PUBLIC HEARING MEMORANDUM

SUBJECT: **Working Session Memo for Petition #422-24** for SPECIAL PERMIT/SITE PLAN APPROVAL to raze the existing dwelling and construct four attached single-family dwellings with dimensional and parking waivers at 640 Watertown Street, Ward 2, Newtonville, on land known as Section 21 Block 26 Lot 18, containing approximately 16,020 sq. ft. of land in a district zoned MULTI RESIDENCE 1 Ref: Sec. 7.3.3, 3.4.1, 3.2.4, 6.2.3.B.2, 5.1.4, 5.1.13 of the City of Newton Rev Zoning Ord, 2017.

SUBJECT: **Petition #422-24** for SPECIAL PERMIT/SITE PLAN APPROVAL to raze the existing dwelling and construct four attached single-family dwellings with dimensional and parking waivers at 640 Watertown Street, Ward 2, Newtonville, on land known as Section 21 Block 26 Lot 18, containing approximately 16,020 sq. ft. of land in a district zoned MULTI RESIDENCE 1 Ref: Sec. 7.3.3, 3.4.1, 3.2.4, 6.2.3.B.2, 5.1.4, 5.1.13 of the City of Newton Rev Zoning Ord, 2017.

ZONING REVIEW MEMORANDUM

Left Side Elevation
 A.2.4 5/8" = 1'-0"

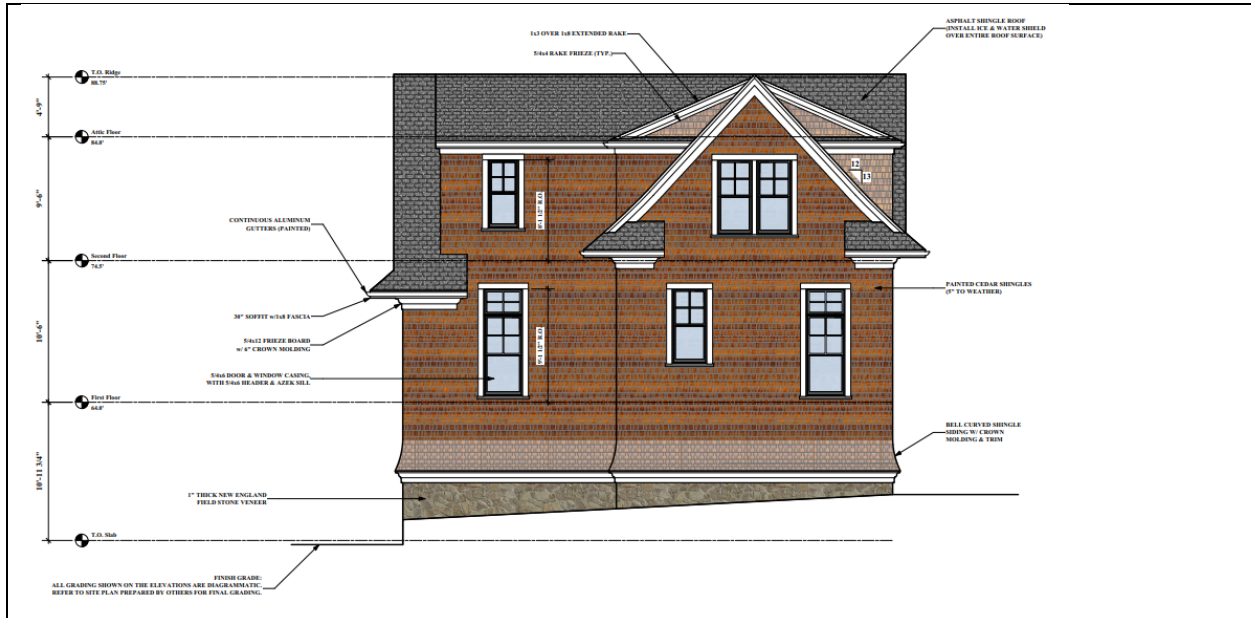
The proposed height is 34.6 feet and 3 stories, with the basement accounting for one of those stories. Given the proposed grading plan and proposed elevations, the height will remain generally consistent from the front façade to the rear.
